# Cruachan Expansion Project – EIA Gatecheck Report

Version 1.0 February 2022

This Gatecheck Report has been prepared to summarise work undertaken by the project team since the submission of the Cruachan 2 Environmental Impact Assessment Scoping Report to the Scottish Ministers in June 2021 and the adoption of an EIA Scoping Opinion on 29th October 2021. The purpose of this report is to explain how the design of the Proposed Development has evolved in response to Scoping responses and to confirm how design and assessment matters raised in EIA Scoping responses are being addressed. The report describes how EIA Design Freeze for the Proposed Development has been reached and outlines the approach to environmental mitigation development, taking account of EIA Scoping responses and local community feedback from the public exhibitions held in July, November and December 2021.

# Appendix A Figure 3: Upper Intake Drawings

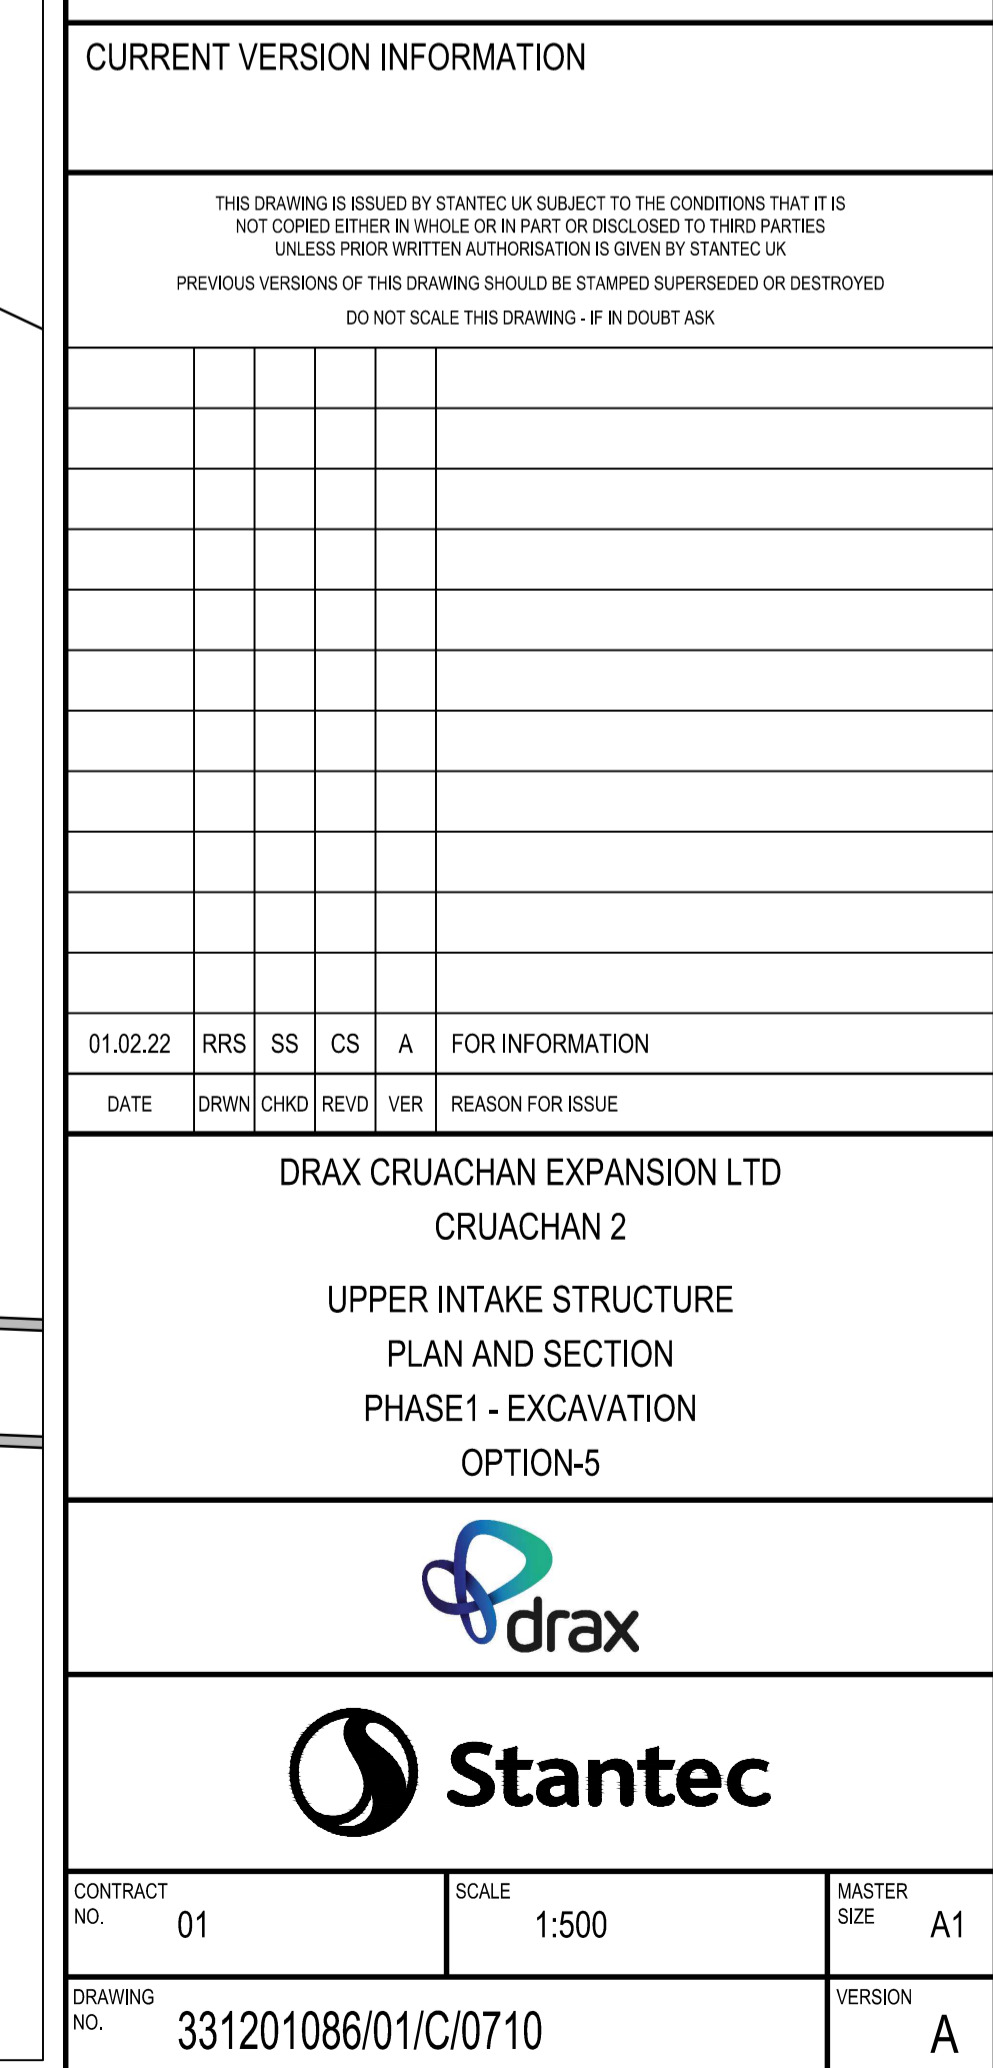
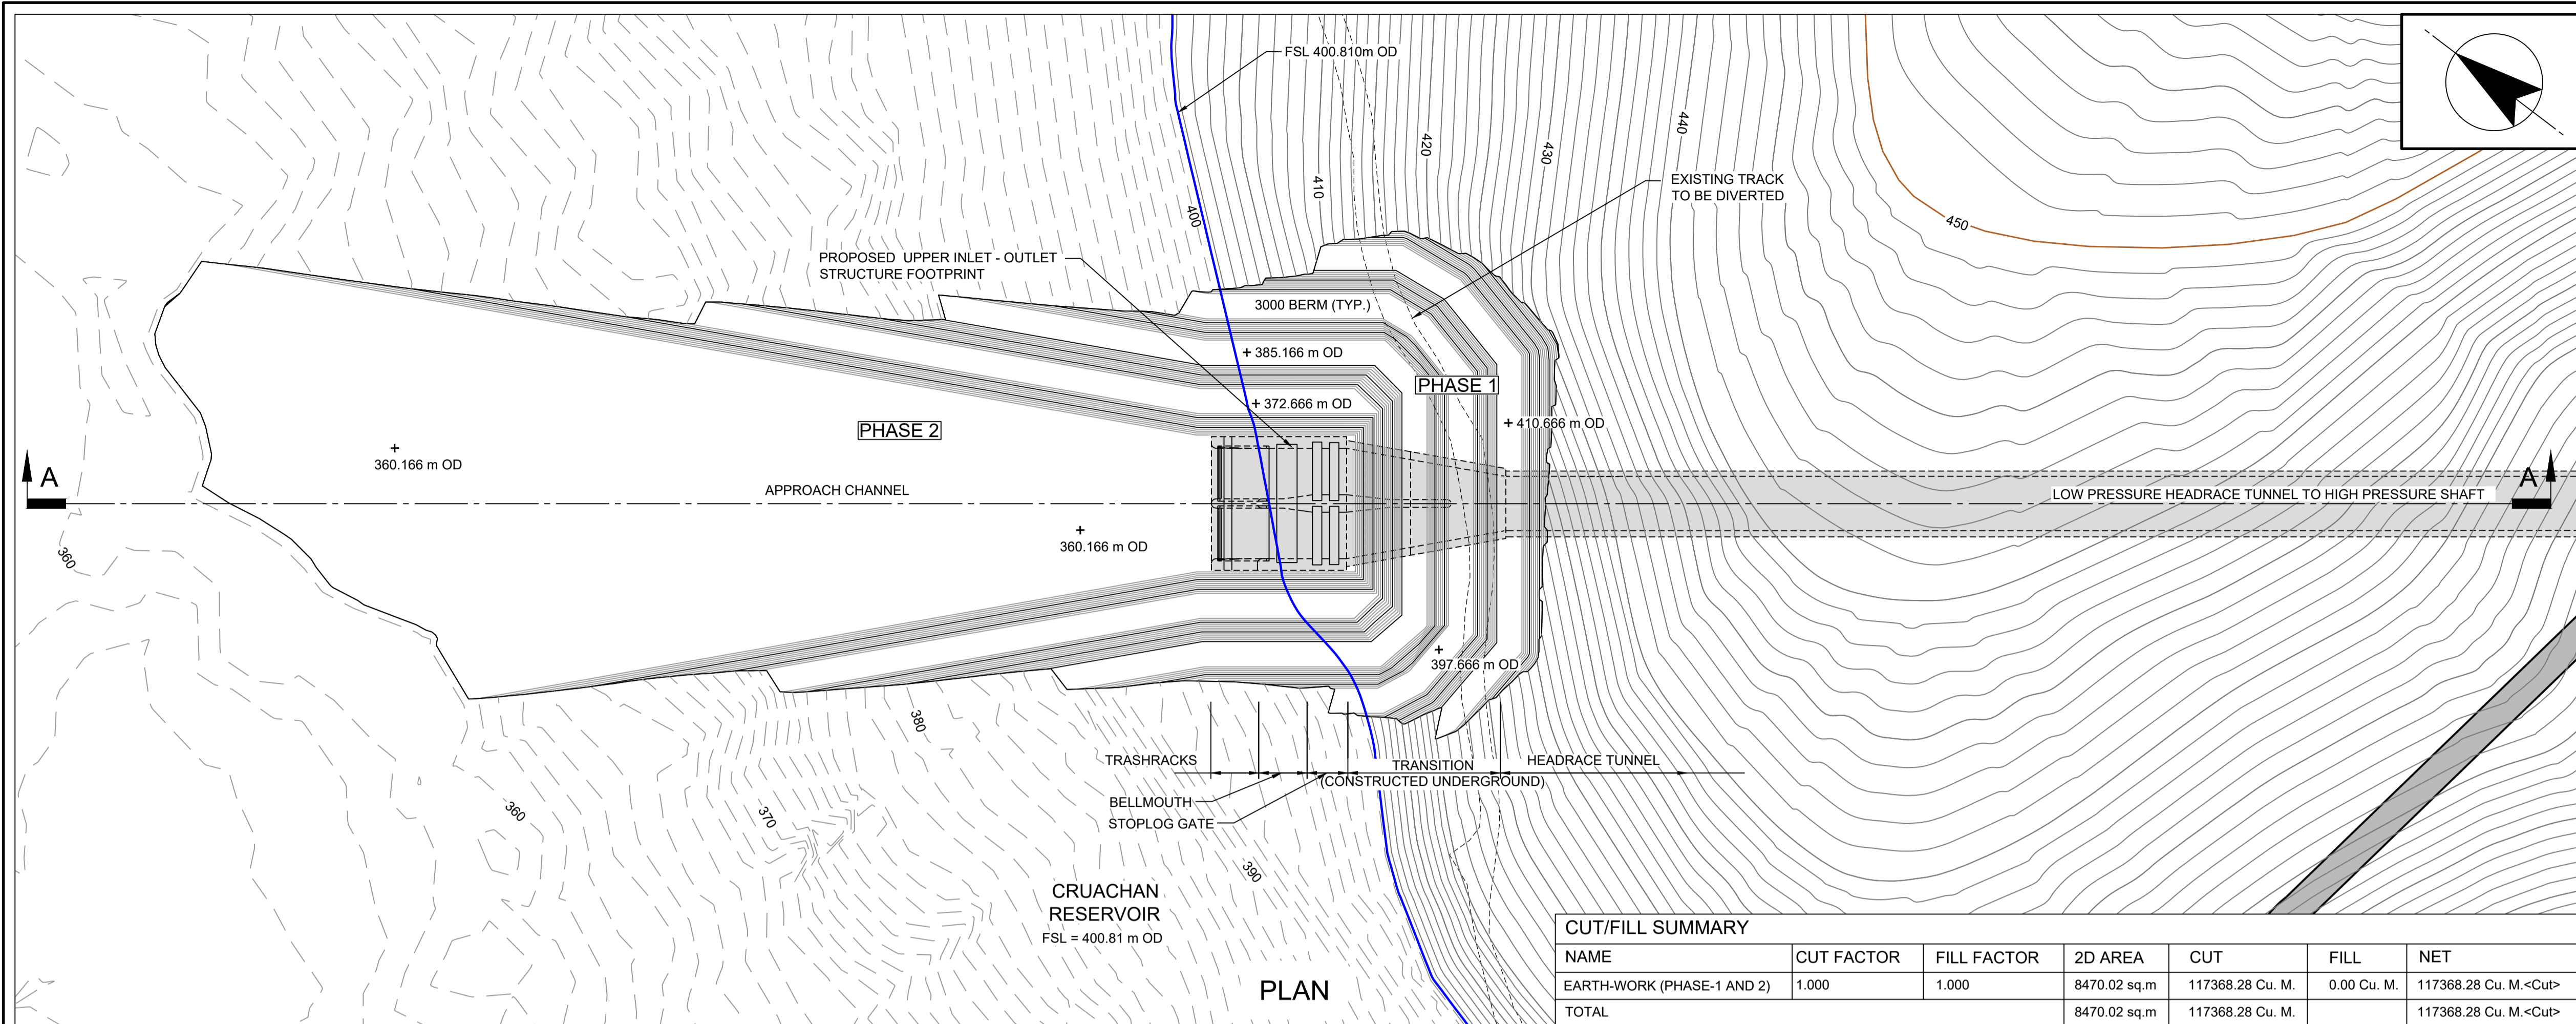
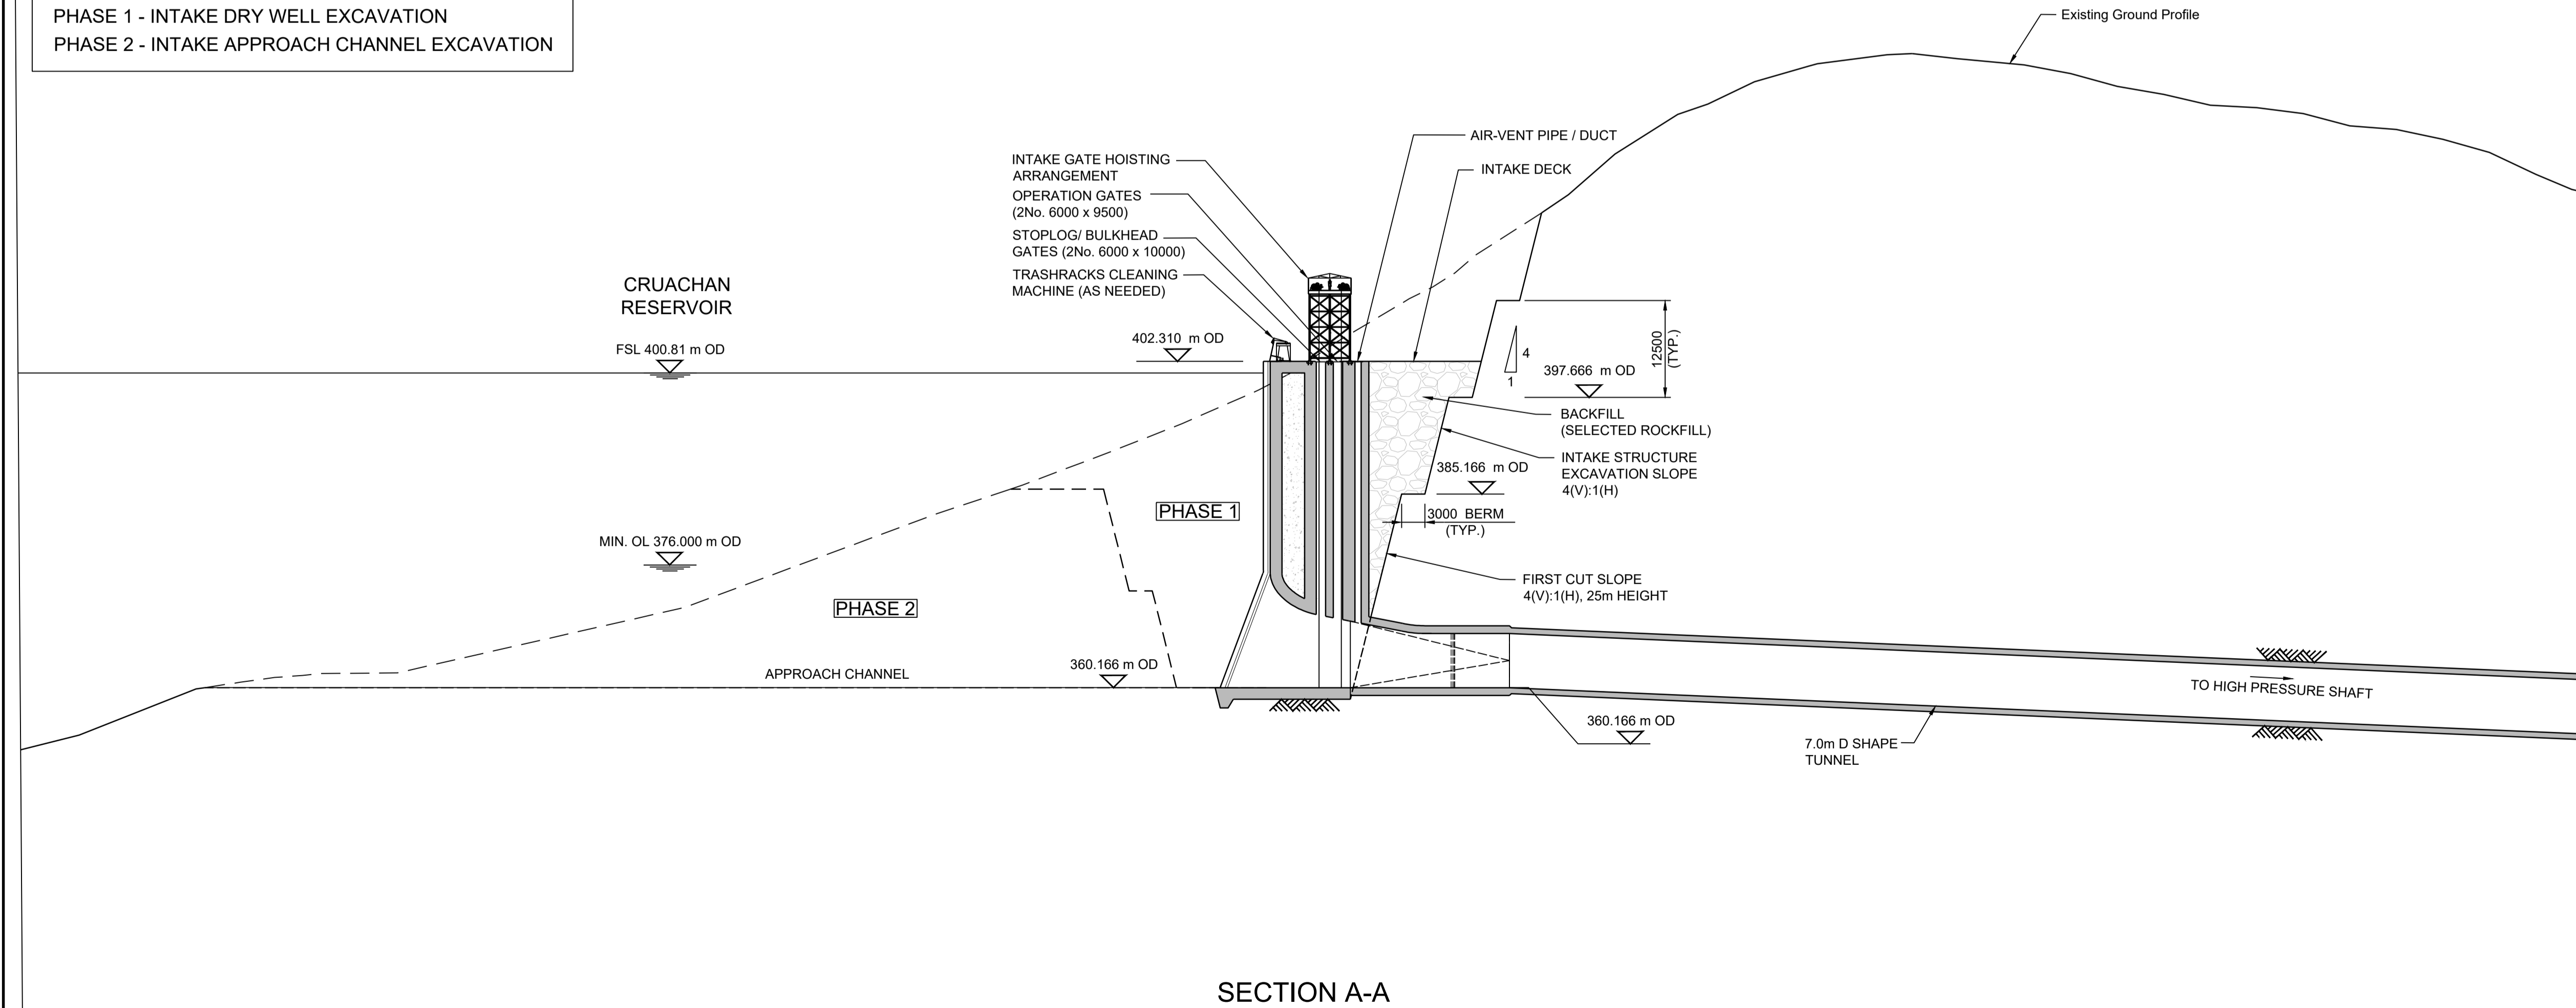
Element of Project	Scoping Report Assumptions (June 2021)	Revised Design (February 2022)
Upper Works	Upper intake structure proposed within Cruachan Reservoir. This would have required extensive structures within the reservoir and meant a full drawdown of water within the reservoir, meaning that Cruachan 1 would have had an outage period of over 6 months.	<p>The intake structure has been relocated to the east, with a significant proportion to be constructed on the eastern bank of the reservoir, on dry land. Although this will result in a need to remove rock from the hillside and the upper intake structure will potentially be more visible (with a larger above ground structure), the need for an underground gate shaft and extensive construction inside the reservoir will be avoided. This significantly de-risks this element of the Proposed Development by enabling construction to take place on the landward side of the reservoir within a dry works area meaning a less complex construction process. It will also reduce the overall drawdown period for the reservoir to around 4-5 weeks. This will allow the existing Cruachan 1 plant to have a significantly reduced outage period.</p> <p>Several iterations of the revised upper intake structure have been developed and the final solution, presented in Appendix A Figure 3 represents a balance between engineering constructability and limiting visual impact as far as reasonably practicable. Further refinement of this part of the project is anticipated, which will further reduce the excavation of rock from the hillside. The current design details therefore represent a worst-case scenario.</p>
